STAFF RECOMMENDATION
2512 Woodlawn Drive
December 19, 2018

Application: New Construction—Addition
District: Hillsboro-West End Neighborhood Conservation Zoning Overlay
Council District: 18
Map and Parcel Number: 10415039600
Applicant: Preston Quirk
Project Lead: Melissa Sajid, melissa.sajid@nashville.gov

Description of Project: The application is to construct a rear addition that would attach the existing single-story garage.

Figure 2: View of house and existing outbuilding from 26th Avenue South

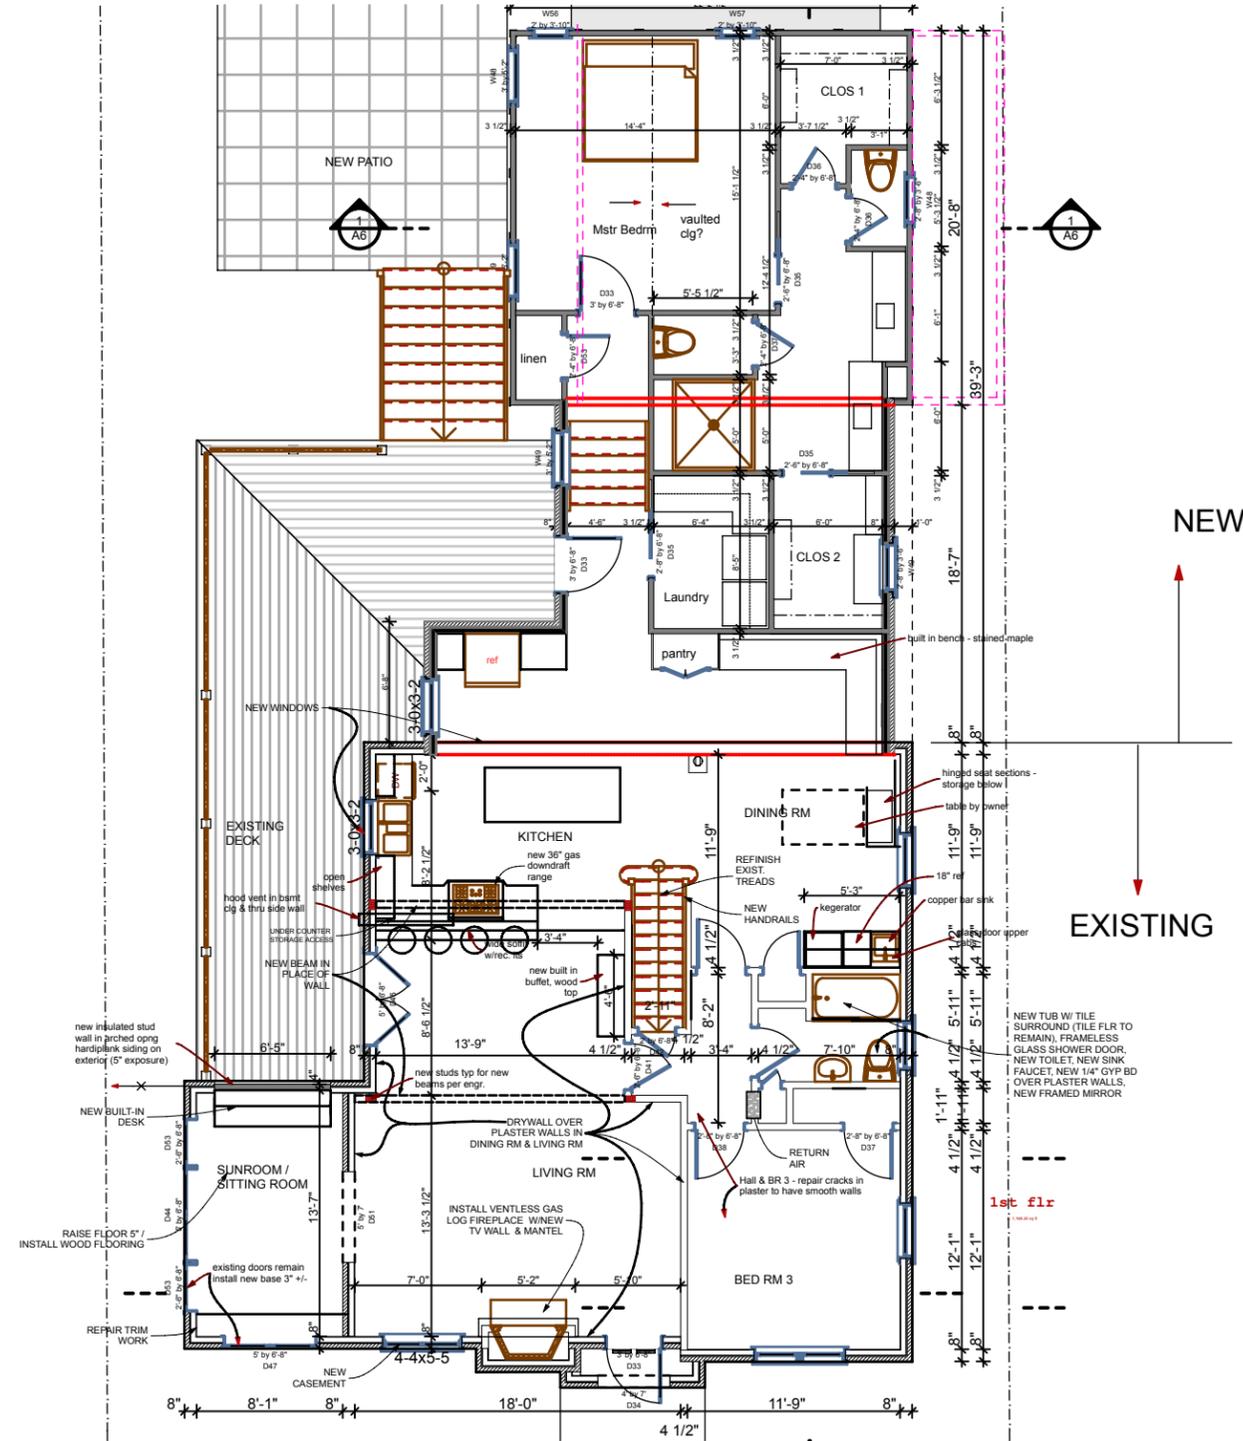
Background: 2512 Woodlawn Drive is a c. 1935 brick Tudor revival that contributes to the character of the Hillsboro-West End Neighborhood Zoning Overlay (Figure 1). The property is located at the corner of Woodlawn Drive and 26th Avenue South. An existing single-story detached garage is located approximately eighteen feet (18') behind the house (Figure 2).

MAIN FLR PLAN

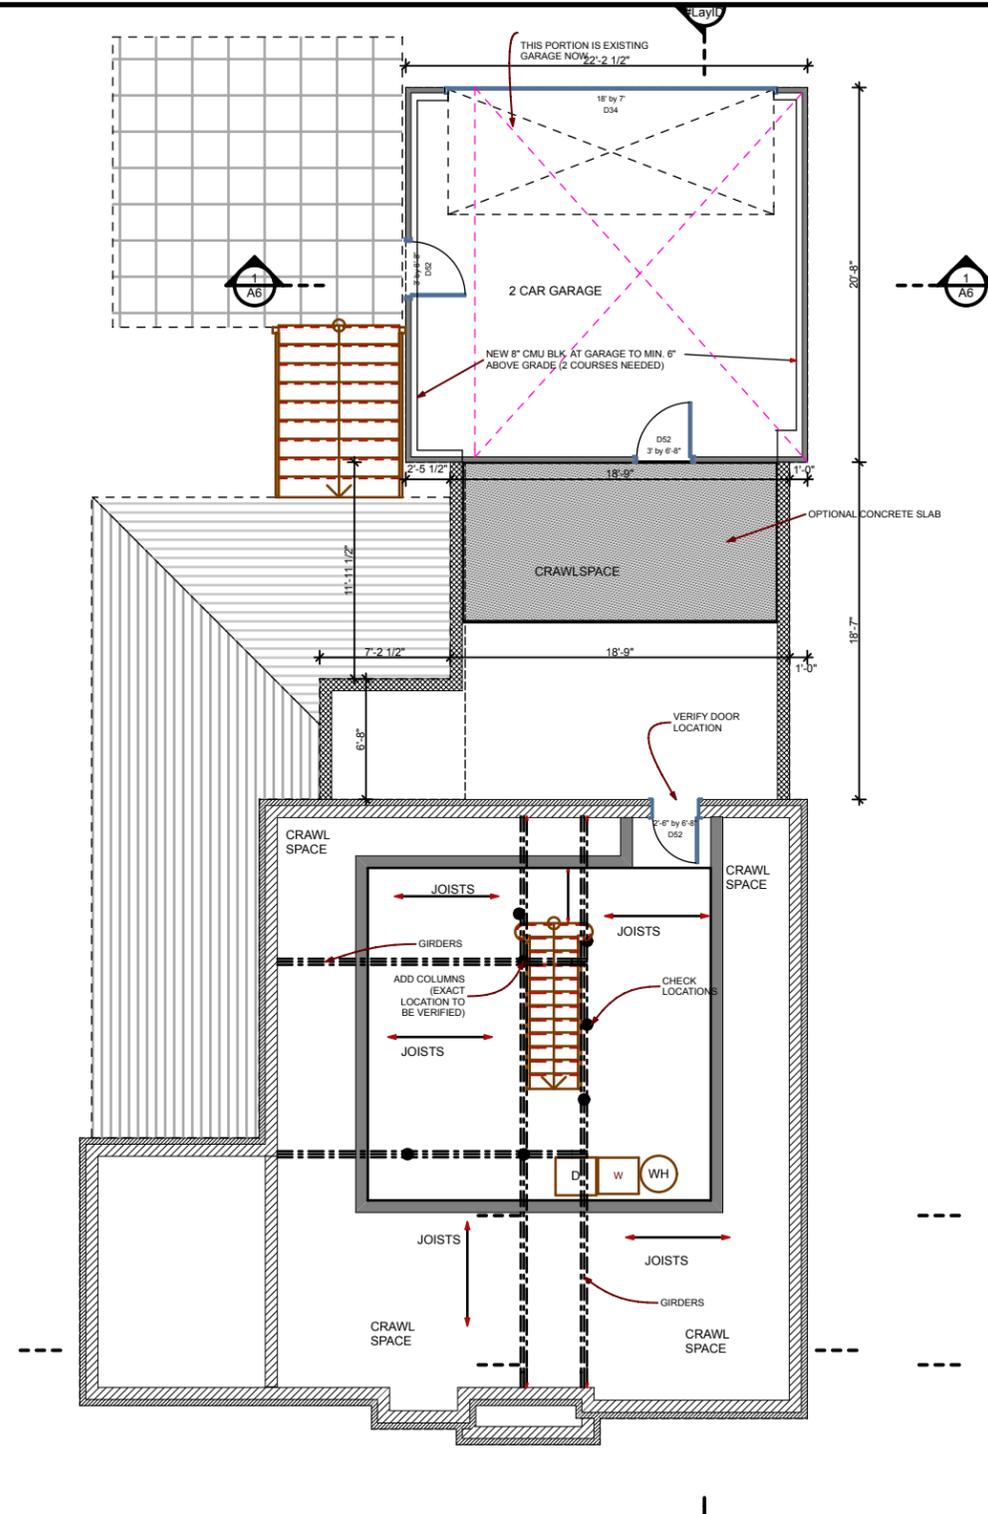
Location & Removability: The addition will be located at the rear of the existing building and will be inset one foot (1') on right side and three feet, six inches (3'-6") on the right side, in accordance with the design guidelines. On the right side, the addition widens at eighteen feet, seven inches (18'-7") back to match the width of the house; this portion is the side wall of the existing garage. The addition is designed so that if the addition were to be removed in the future, the historic character of the house would still be intact.

BSMT, ROOF PLANS

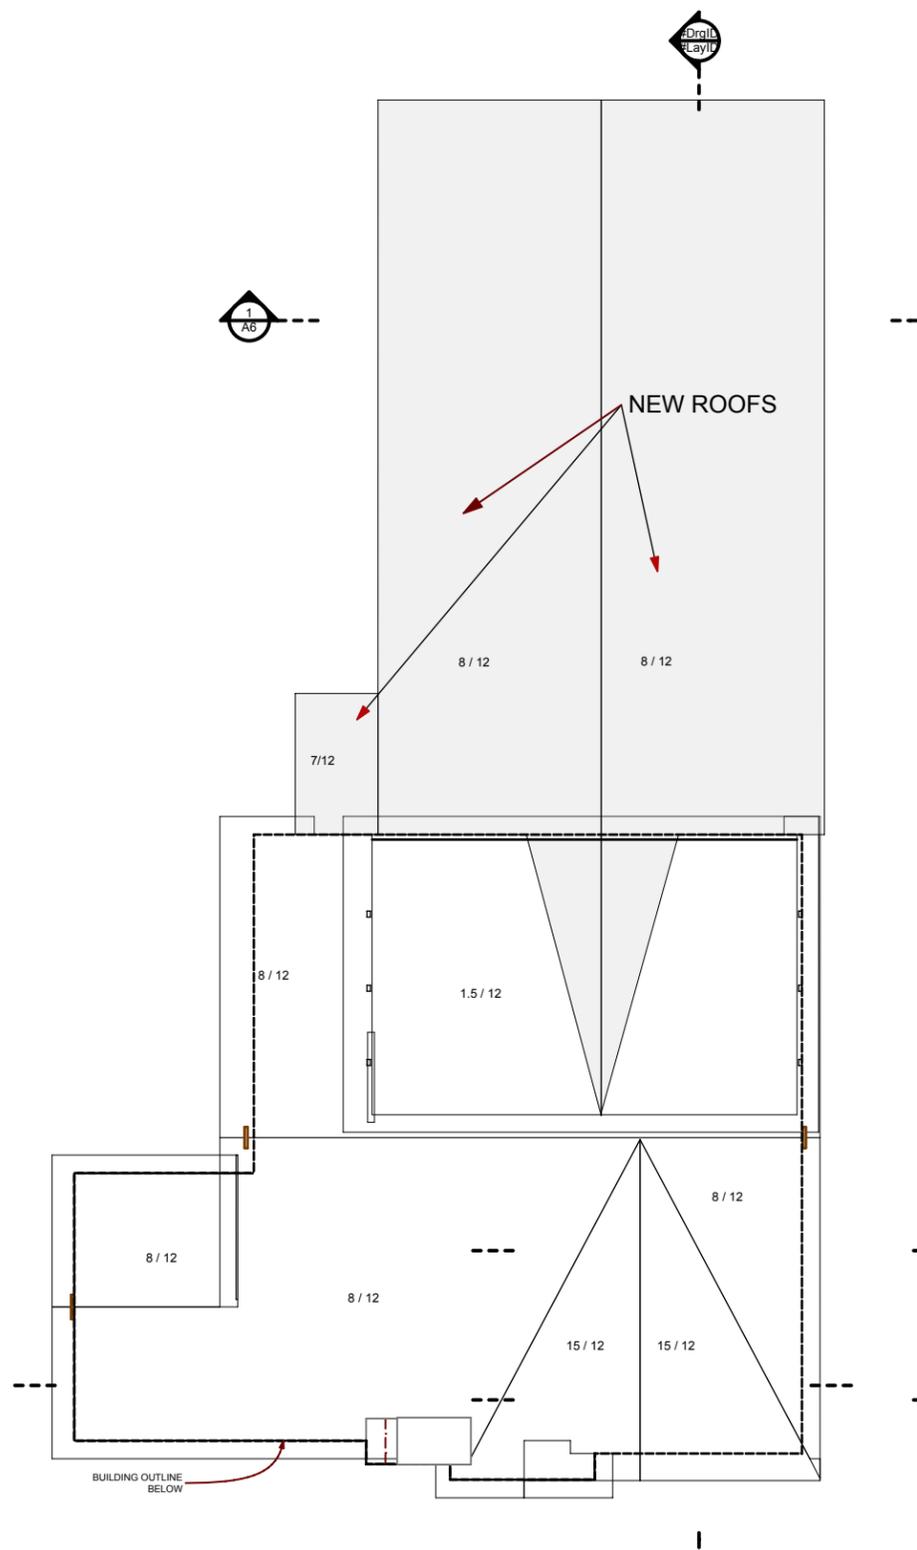
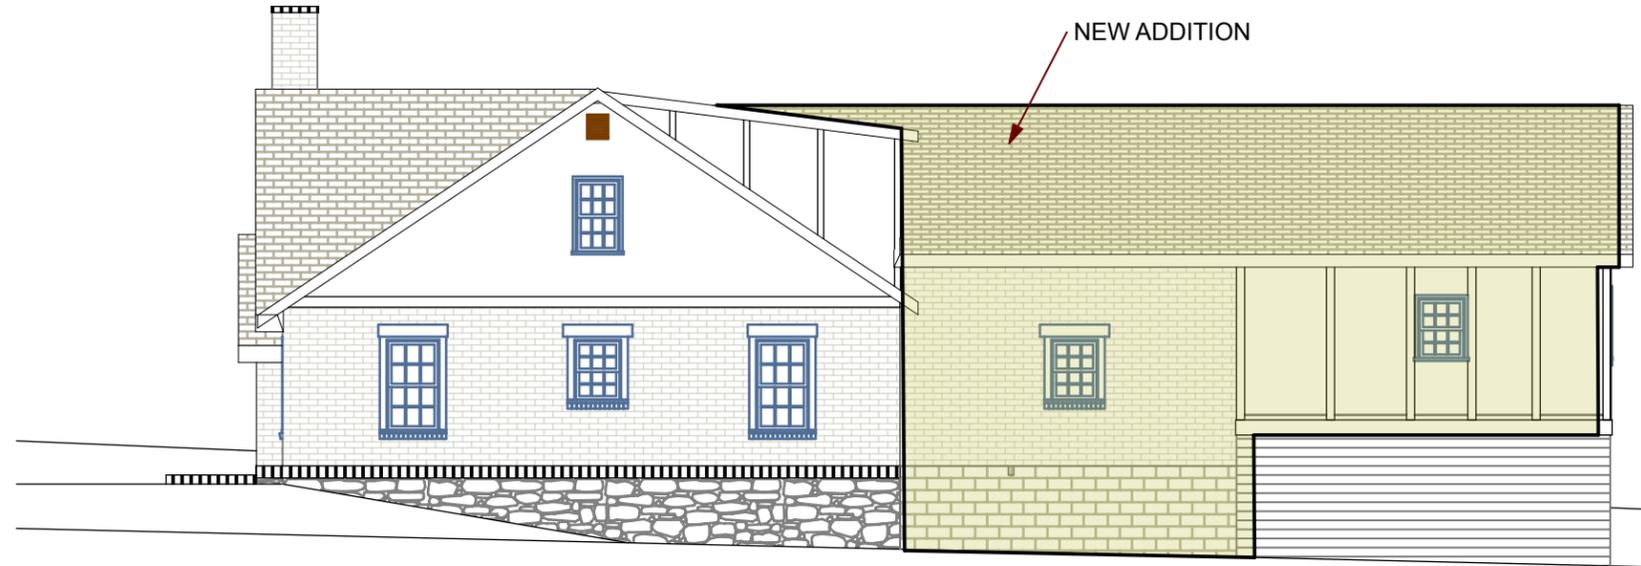
The plan proposes to incorporate the existing single-story detached garage into the new addition. The design guidelines state that attached garages may be appropriate when they are located at basement-level. While the existing garage, if attached, would not be located fully at basement-level, the majority would be at basement-level. In addition, the existing garage is located less than twenty feet (20') from the rear of the house, which makes it difficult to construct any rear addition without demolishing the existing outbuilding. Furthermore, incorporating the garage into the addition would not result in an inappropriate massing for the addition. For these reasons, staff finds that the proposed design, which incorporates the existing garage, could be appropriate in this case.

Roof form: The historic house has a cross-gabled roof and includes an earlier rear dormer addition that has a shed roof. The proposed addition incorporates a rear gable with a pitch of 8/12, which is the same as the side gables on the historic house. Staff finds that the roof form and pitch of the proposed side addition are compatible with the roof form of the historic house. The project meets section II.B.1.e.

ELEV - SIDES

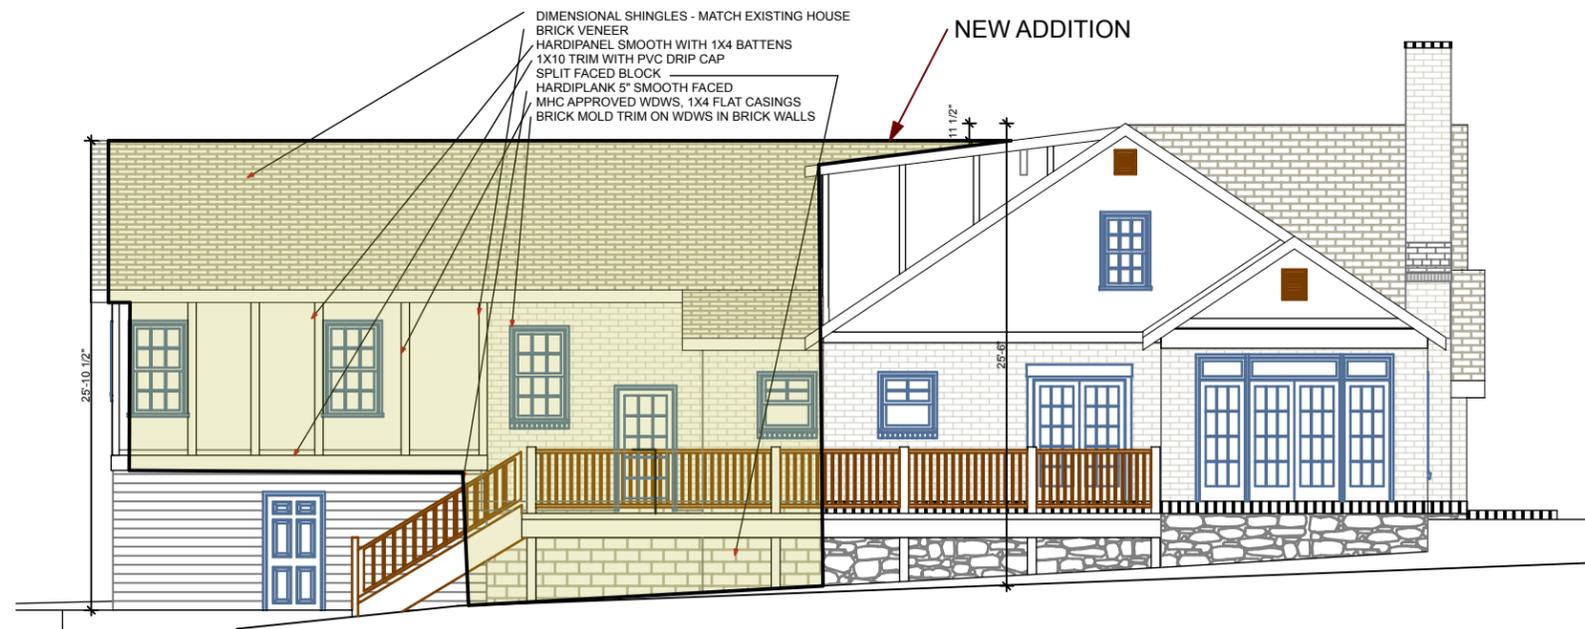
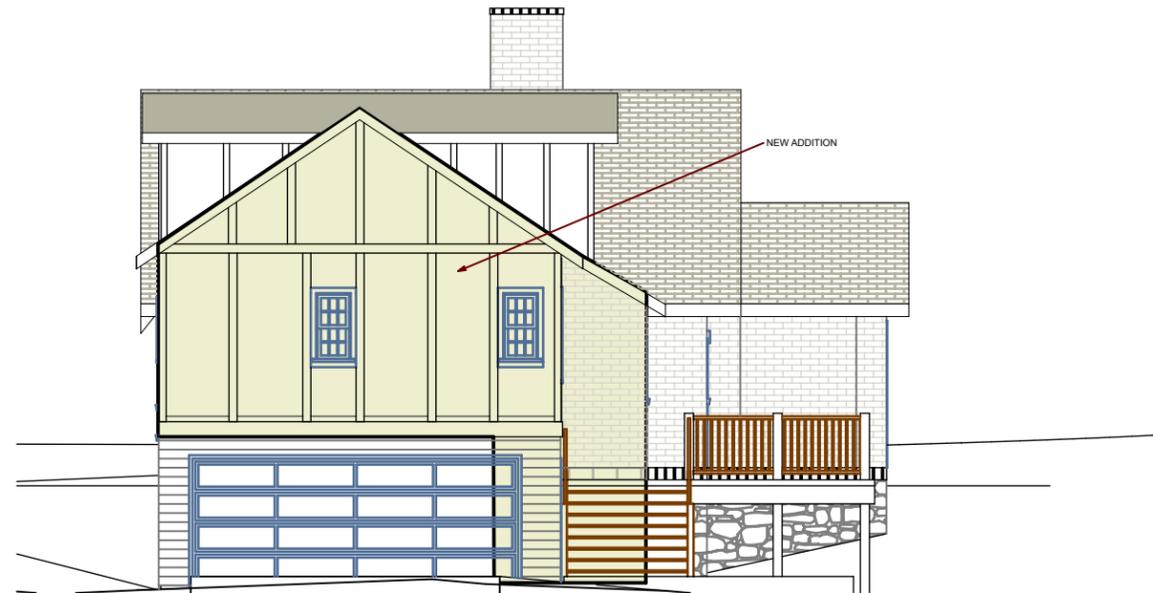
As proposed the addition is neither taller nor wider than the historic house. The eave height and foundation height, however, will both be approximately two feet (2') taller than the eave and foundation heights on the historic house. The taller foundation and eave heights are the result of incorporating the existing single-story detached garage. Staff finds that the proposed foundation and eave heights could be appropriate in this case since they do not result in a two story addition to a one and one-half story house.

Proportion and Rhythm of Openings: No changes to the window and door openings on the existing house were indicated on the plans. The windows on the proposed addition are all generally twice as tall as they are wide, thereby meeting the historic proportions of openings. There are no large expanses of wall space without a window or door opening. Staff finds the project's proportion and rhythm of openings to meet Section II.B.1.g.
